EPA Superfund Record of Decision:

Hanford 200 Area (USDOE), (200-UP-1 Operable Unit) Benton County, WA 2/11/1997

DECLARATION OF THE RECORD OF DECISION

Figure 2. Location of 200-UP-1 Groundwater Operable Unit.

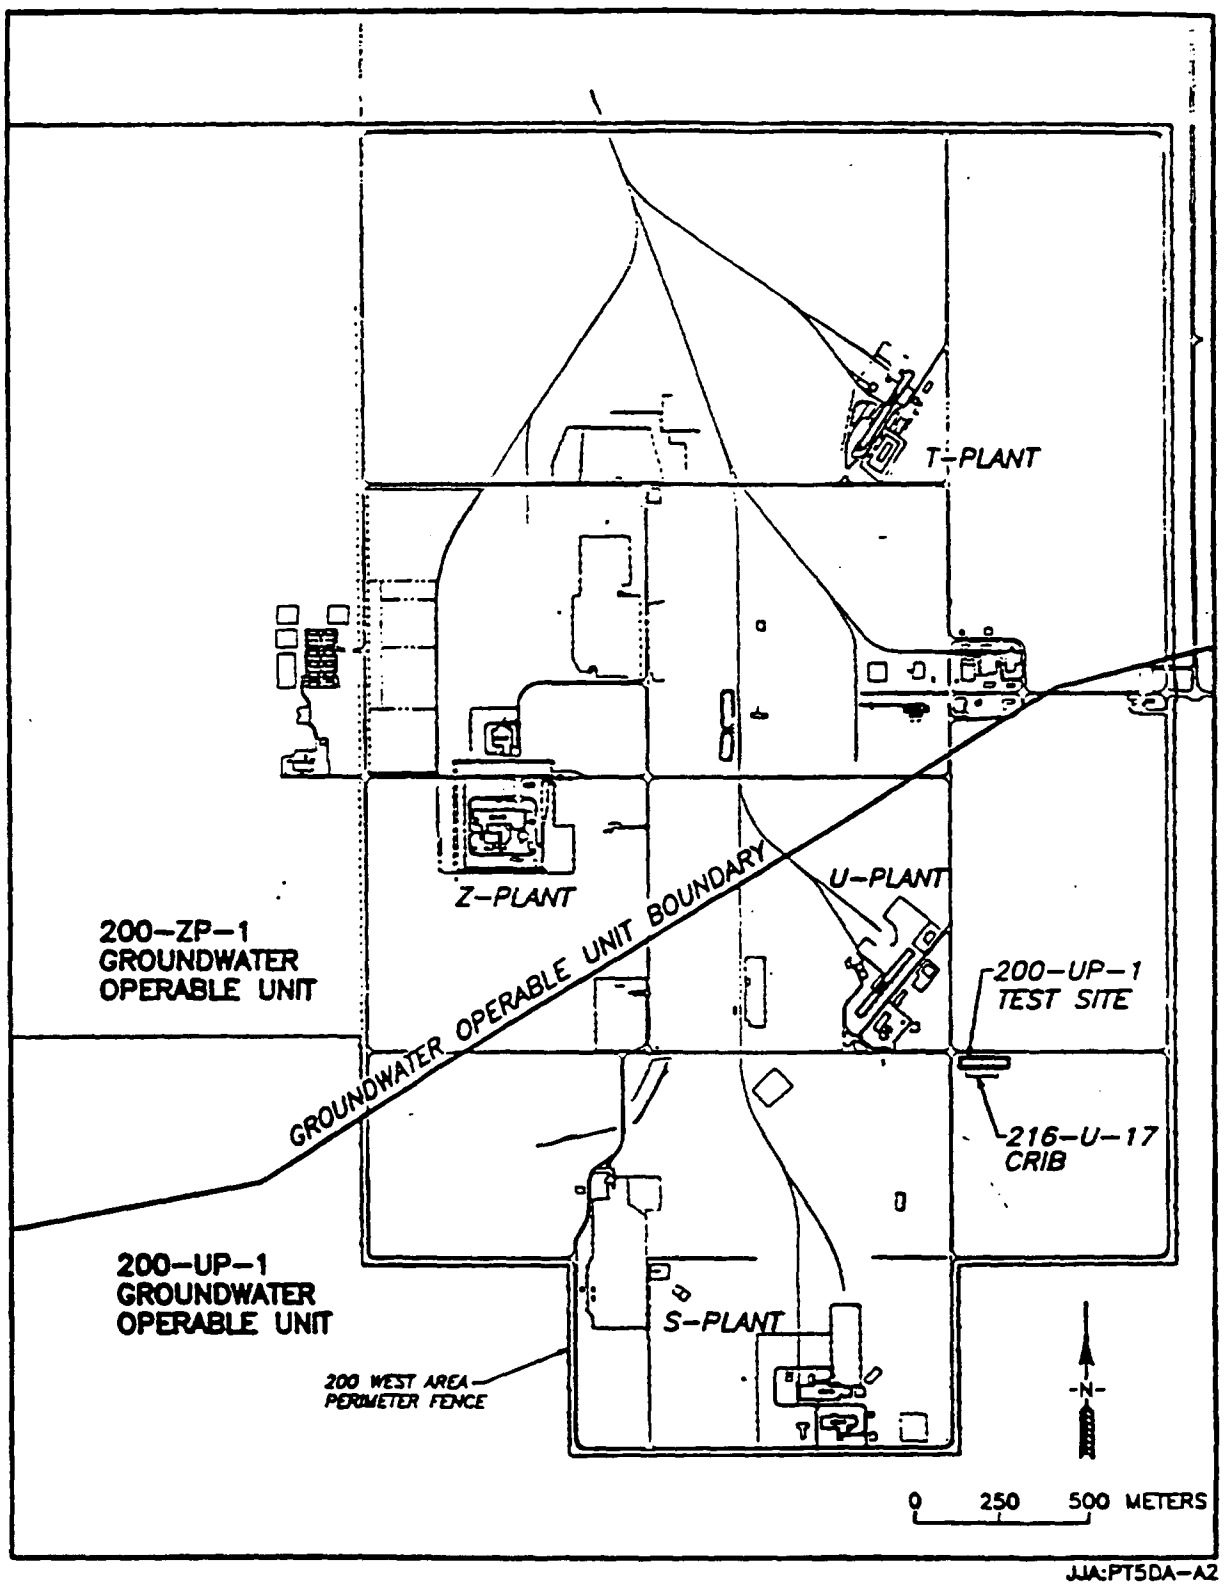
Page 3, Figure 2

Figure 2 has an unacceptable lack of detail. All groundwater monitoring wells should be shown along with measurements of the contaminants. Additional figures should be shown to map each of the plumes individually. The carbon tetrachloride plume is not shown on Figure 2.

The maximum concentrations for each of the contaminants are not specifically shown on Figure 2.
